37/3-96A 7135 Carroll Avenue  
(Takoma Park Historic District)

SUBJECT: Historic Area Work Permit

## HISTORIC PRESERVATION COMMISSION STAFF REPORT

Address: 7135 Carroll Avenue	Meeting Date: 1/10/96
Resource: Takoma Park Historic District	HAWP: Alterations
Case Number: 37/3-96A	Tax Credit: No
Public Notice: 12/27/95	Report Date: 1/3/96
Applicant: Hevia/Paul Cooksey, Agent	Staff: Patricia Parker
PROPOSAL: Enclose first floor rear porch	RECOMMEND: Approve w/conditions

TOP RAIL WM-8840  
 1 1/2" x 3 5/8"

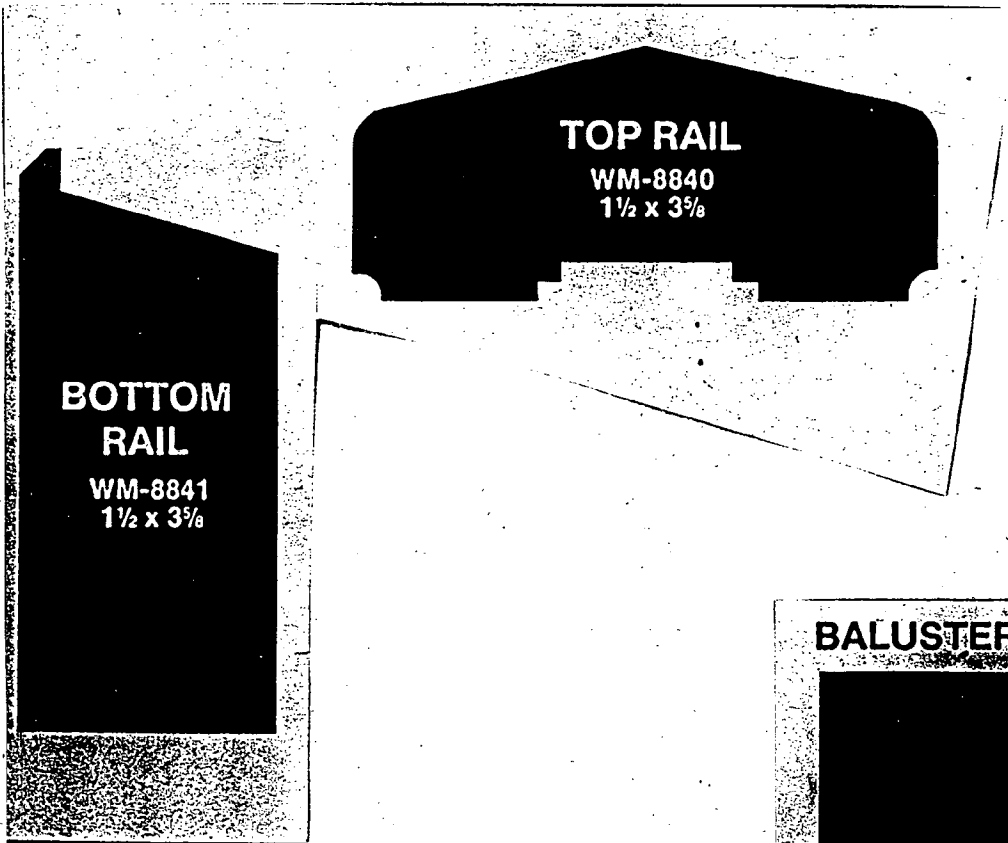
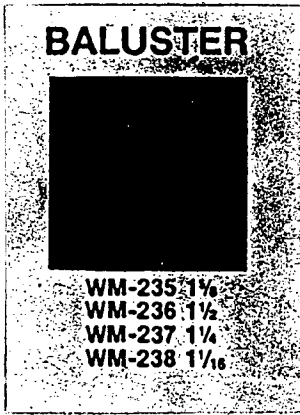
Staff also requested that the applicant provide additional documentation to describe the landing and stair leading to grade from the proposed enclosure. The applicant has verbally described that a landing off the new enclosure would be made of wood with wood handrail and wood steps to grade.

1. The west wall of the new enclosure be indented to align with the upper floor.
2. The applicant should submit additional documentation for staff review and approval, fully describing the new rear stair and handrail. This documentation must be approved by HPC staff prior to completion of HAWP processing.
3. Wood trim details, especially around the new door and window, should match the existing trim and be a minimum of 4" in width; and

EXISTING FLOOR FRAMING 1/2" = 1'

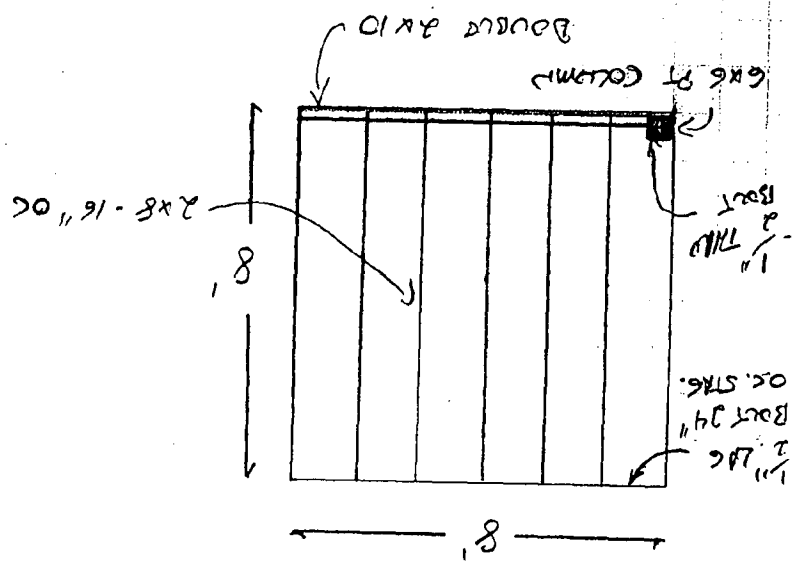
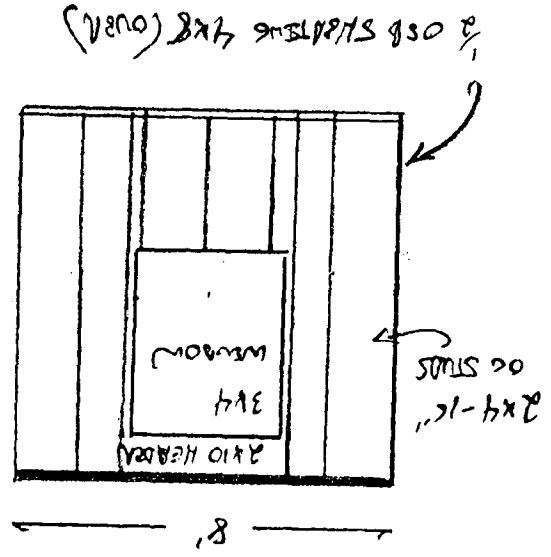
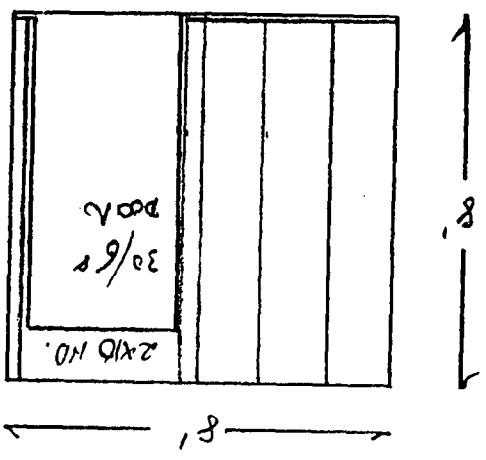
Contractor has not supplied elevations. ~~It seems~~  
He seems ~~to be~~ <sup>unused</sup> to working at that level -  
Drawings supplied are actually framing plans +  
elevations!

~~///~~ We should let him know ASAP if we need to  
push for more drawings.

SIDING TO MATCH EXISTING HOUSE (ASBESTOS) STAINCLE  
 BACK DOOR - STAINLEY STEEL DOOR  
 6-PANEL W/ 2 LIGHT AT TOP 2  
 PANELS.

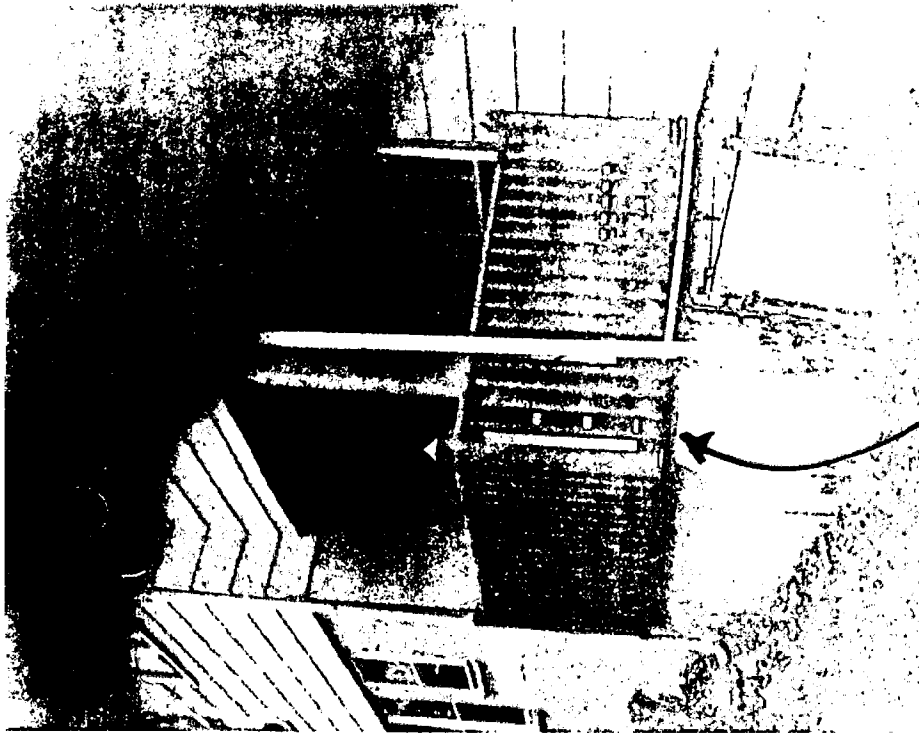
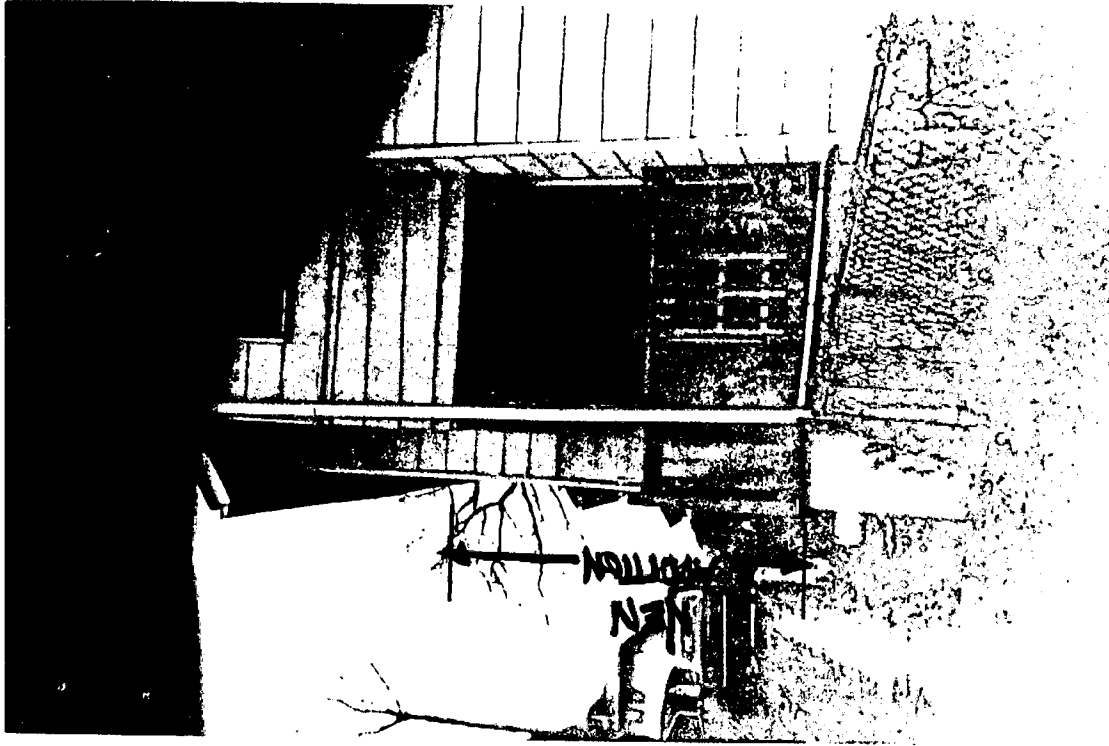
Staff feels the current proposal with its small shed roof is awkward in appearance. Staff recommends that the western wall of the new enclosure be adjusted to align with the indented wall of the main floor above at the rear.

Staff feels that because the steel six-panel door with two lights in the top panels would face the rear yard and not be visible from the public street, the applicant's choice of material is not problematic. The trim for new openings should be of wood and a minimum of 4" in width.
